GRADING AND EROSION CONTROL PLAN

JUDGE ORR ROAD RV PARK AND STORAGE

EL PASO COUNTY, COLORADO

SITE MAP

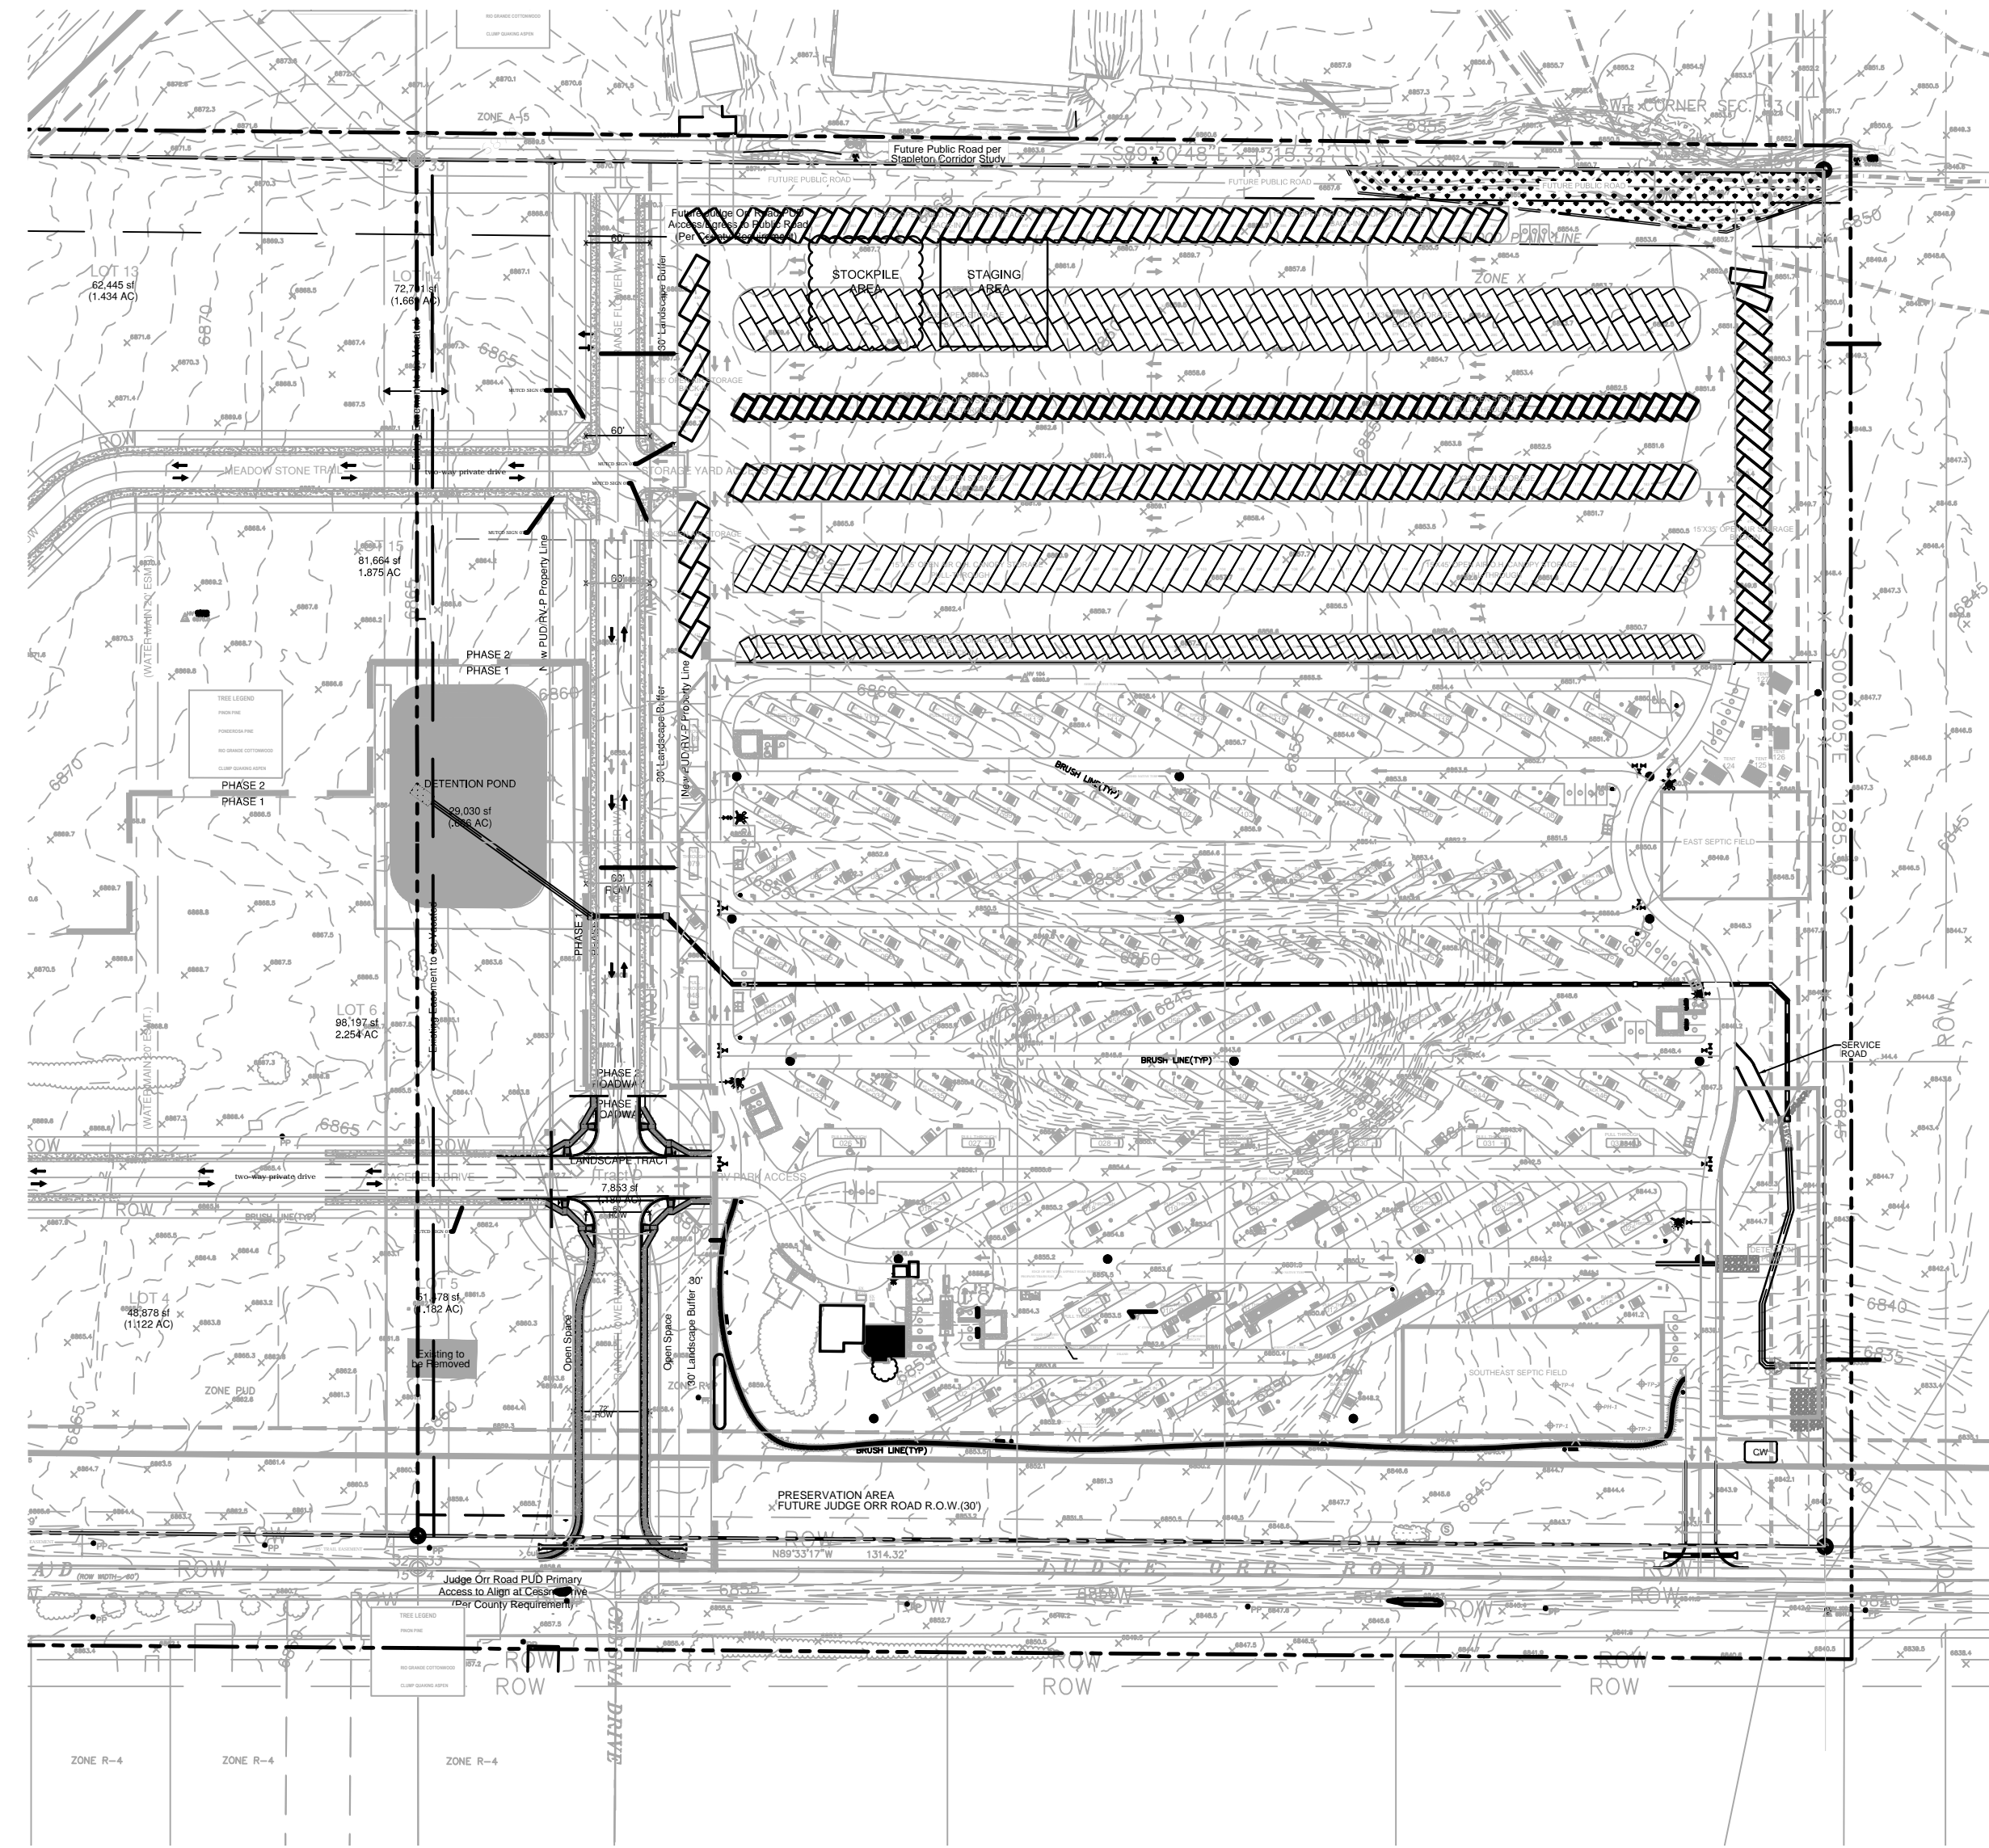
Provide benchmark and basis of bearing

JUDGE ORR ROAD RV PARK & STORAGE
 COLORADO SPRINGS, COLORADO
 DRAINAGE, GRADING & EROSION CONTROL PLAN

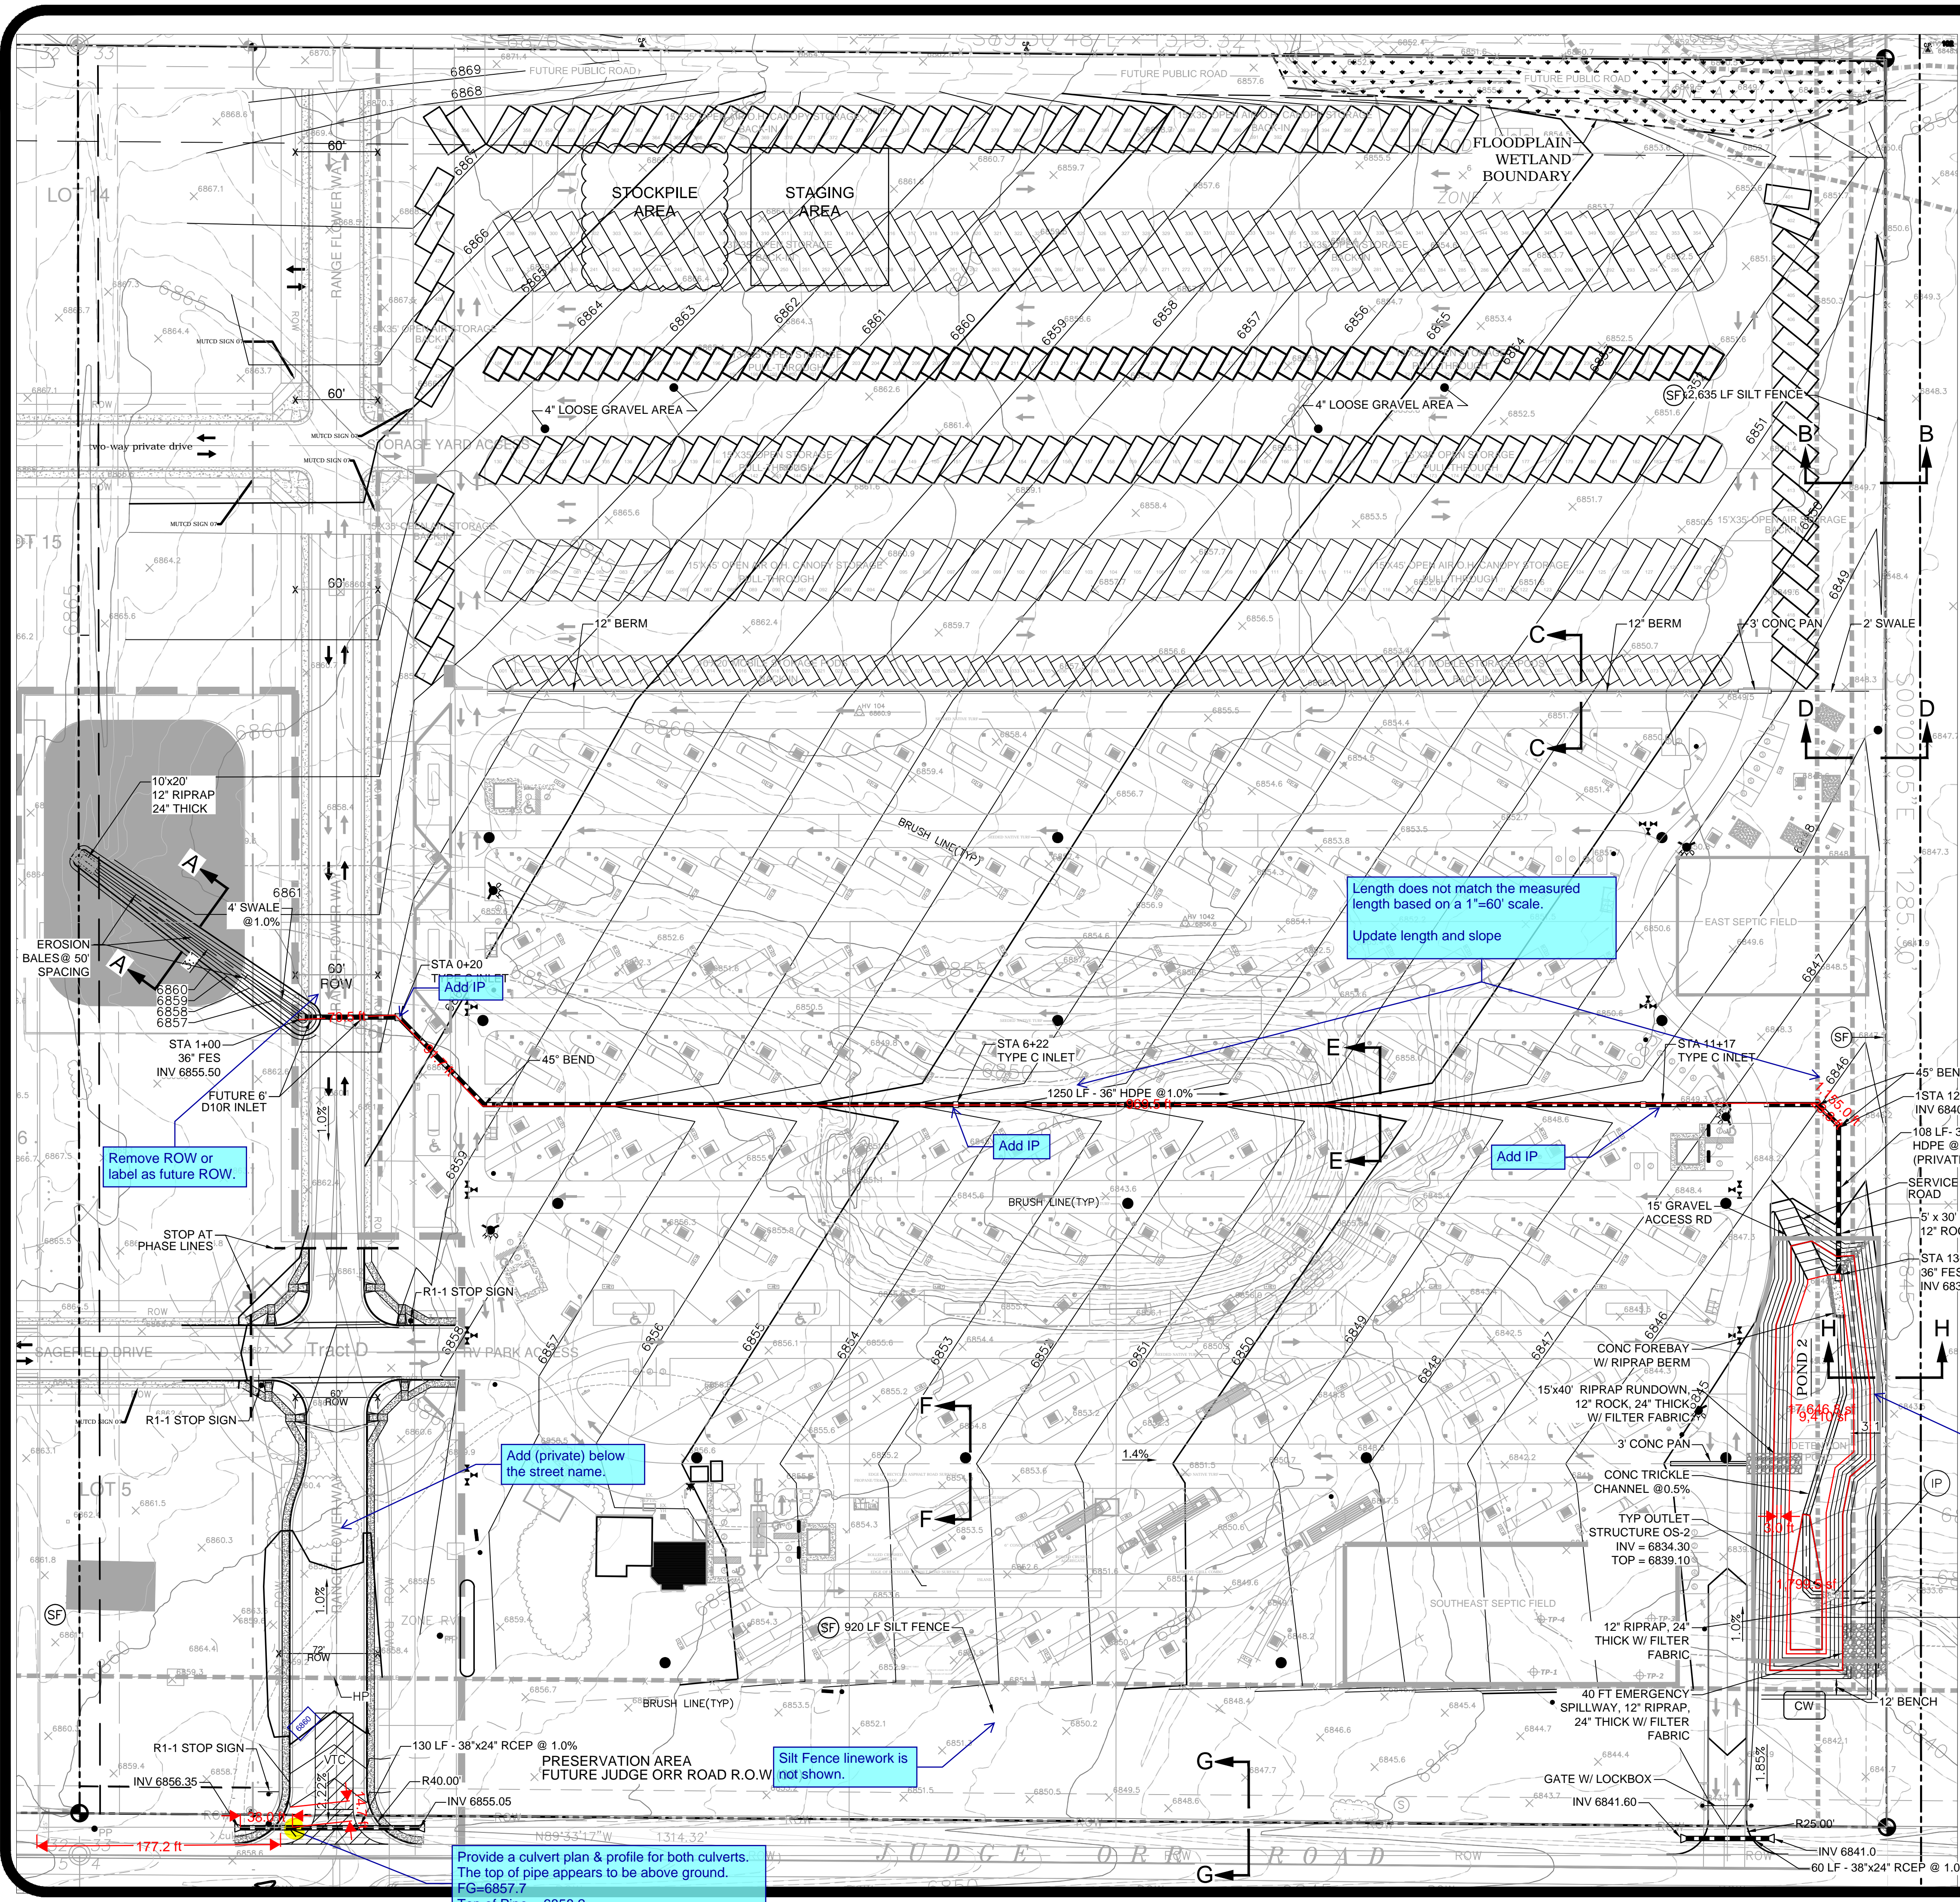
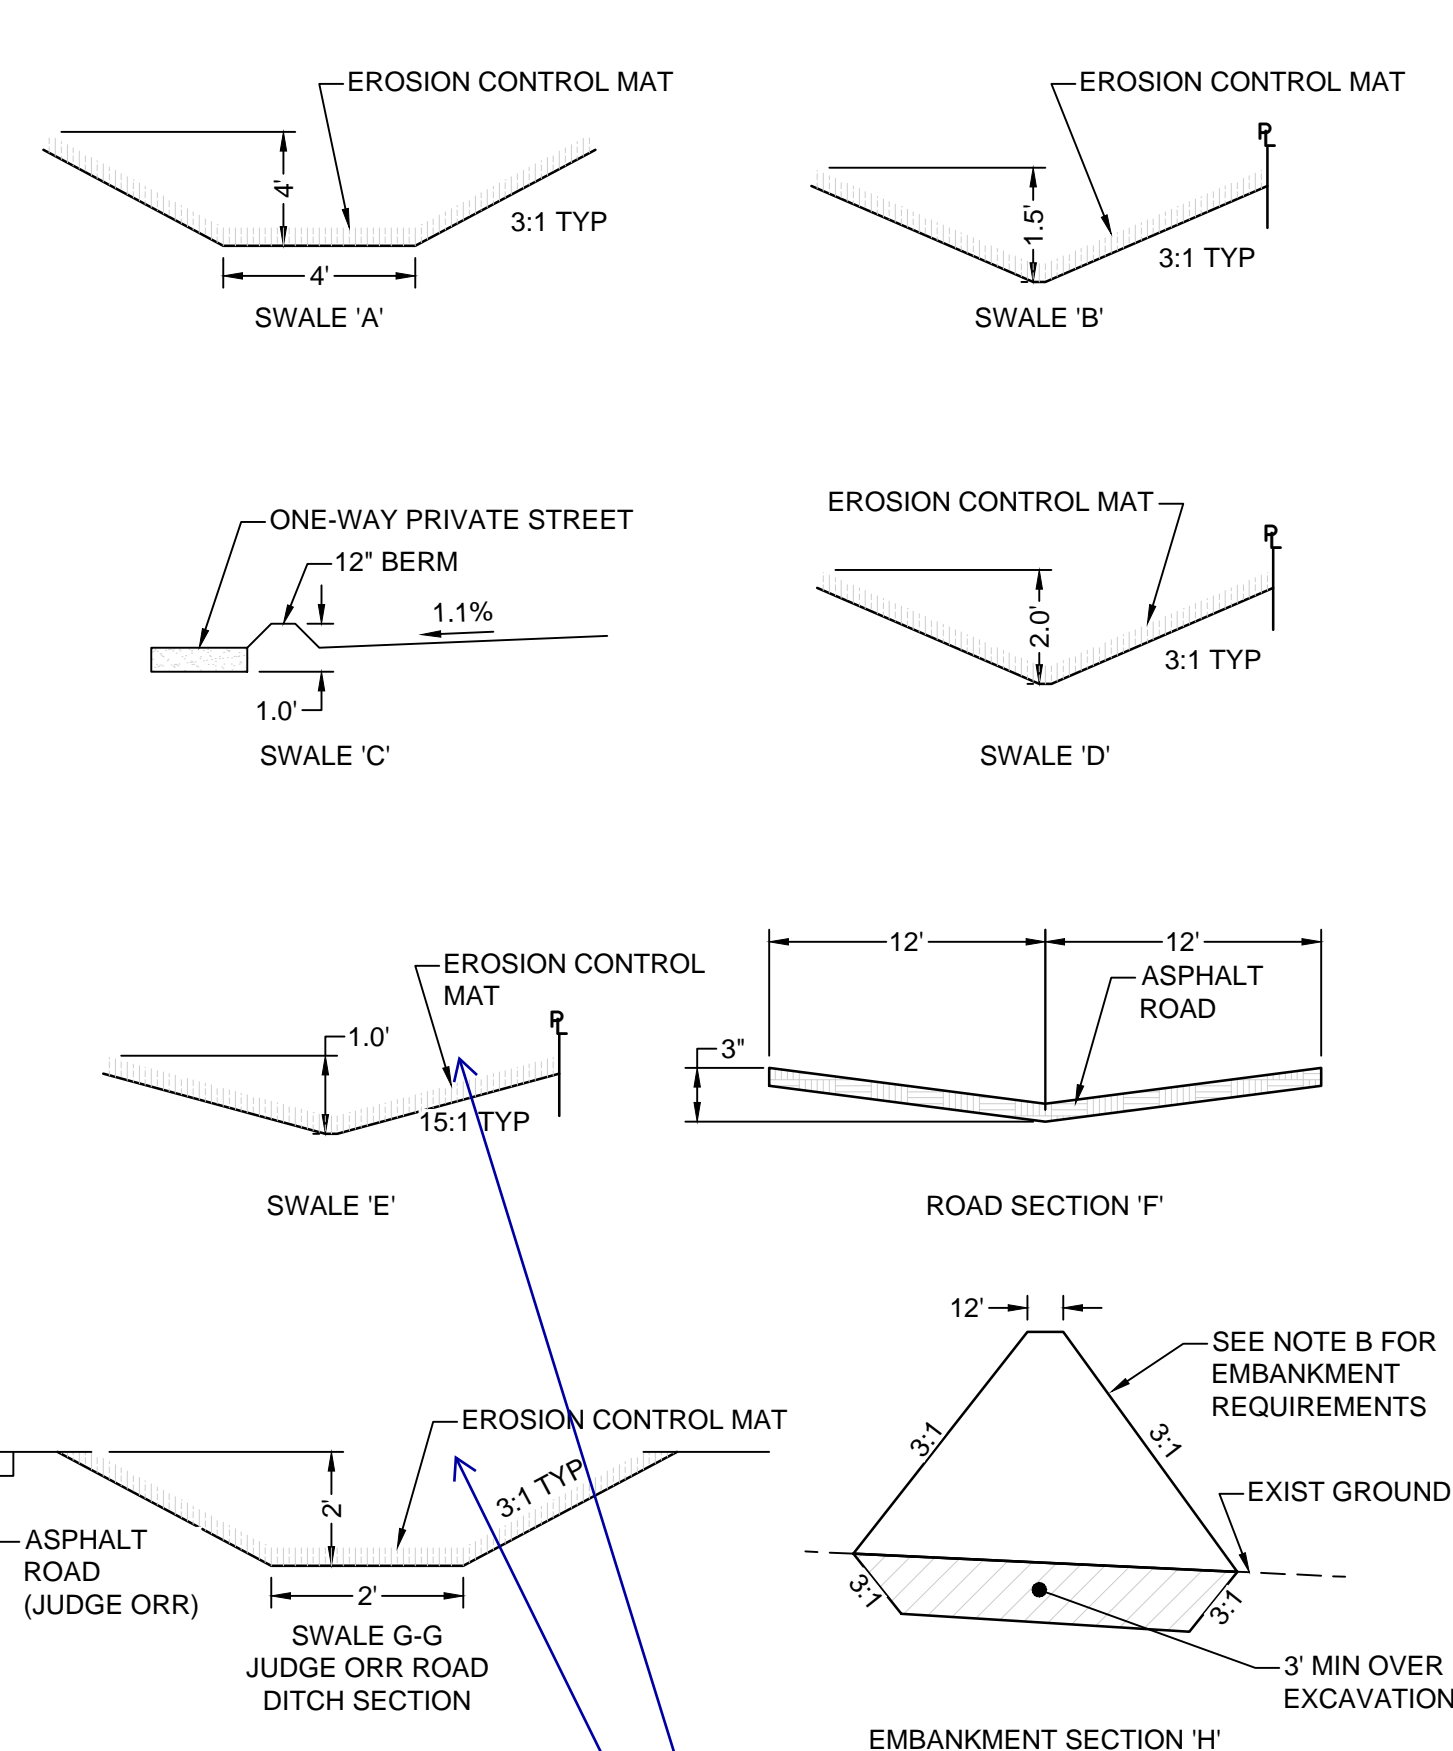
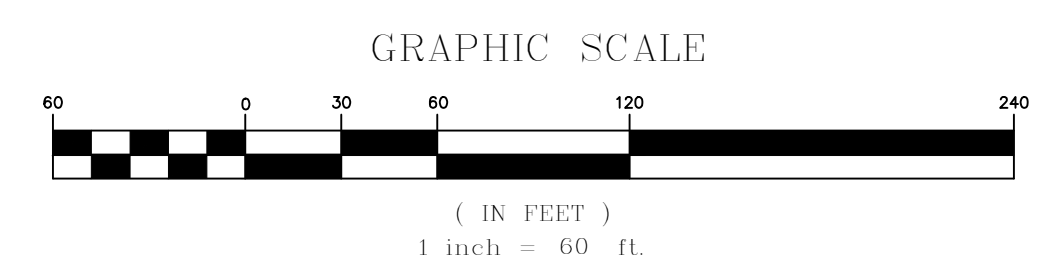
Callout the specific product to be used and in the appendix include the product specification that shows it is designed to handle the specific Froude number calculated. Typ. all

See drainage report comment to Pond 2 UD-Detention worksheet regarding the redlined areas.

Length does not match the measured length based on a 1"=60' scale. Update length and slope

Add (private) below the street name.

Silt Fence linework is not shown.

Provide a culvert plan & profile for both culverts. The top of pipe appears to be above ground. FG=6857.7 Top of Pipe = 6858.2

Add IP

Remove ROW or label as future ROW.
